**ALERT SERVICE BULLETIN**

**NO.** 205-01-81

**MODEL AFFECTED:** 205A/205A1

**SUBJECT:** MAGNETIC BRAKE P/N 204-001-376-003, ONE TIME INSPECTION OF.

**FIGURE 1**

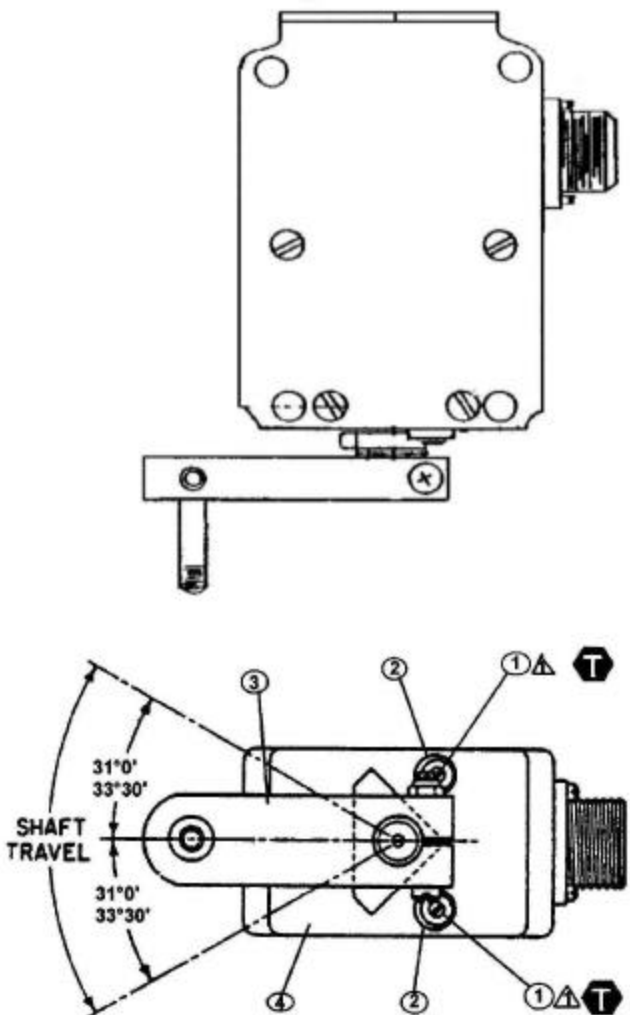
6. Using a suitable torque wrench and screw driver bit apply 10 inch/lbs (1.12 Nm) force to screw(s) (1, figure 1) in a counterclockwise direction. If screw(s) (1) do not move, proceed to step 12. If any movement is found on screw(s) (1) proceed to the following steps.

If the inspection reveals that screw(s) (1) has disengaged, inspect arm assembly (4) for mechanical damage created by screw(s) (1). If mechanical damage is found, the depth shall not exceed 0.030 inch (0.762 mm). Acceptable damage may be smoothed and treated in accordance with the Standard Practice Manual Chapter 3 for Chemical Film. If damage is greater than 0.030 inch (0.762 mm) contact Product Support Engineering.

7. Remove screw(s) (1) and stop limit(s) (2) from magnetic brake (4).

8. Clean residue adhesive from magnetic brake (4) screw holes and screw(s) (1) with compressed air.
9. Apply adhesive (C-320) to screw (1) threads and install in magnetic brake (4) hand tight.
10. Adjust the stop limit(s) (3) to achieve the arm assembly shaft travel as per dimensions in BHT-205-MM Maintenance Manual, Chapter 27.
11. Once shaft travel is obtained, torque screws (1) 5 to 10 in-lbs (0.56 to 1.12 Nm).
12. Apply torque seal inspection ink to screws (1) and to stop limits (2).
13. Re-install cyclic fore & aft and lateral magnetic brakes into aircraft.
14. Re-install cyclic and anti-torque magnetic brake access panels.
15. Connect battery.
16. Make an entry in the helicopter historical records indicating compliance with this Alert Service Bulletin.

- Bond screw with adhesive C-320
- 5 to 10 IN-LBS  
(0.56 TO 1.12 Nm)
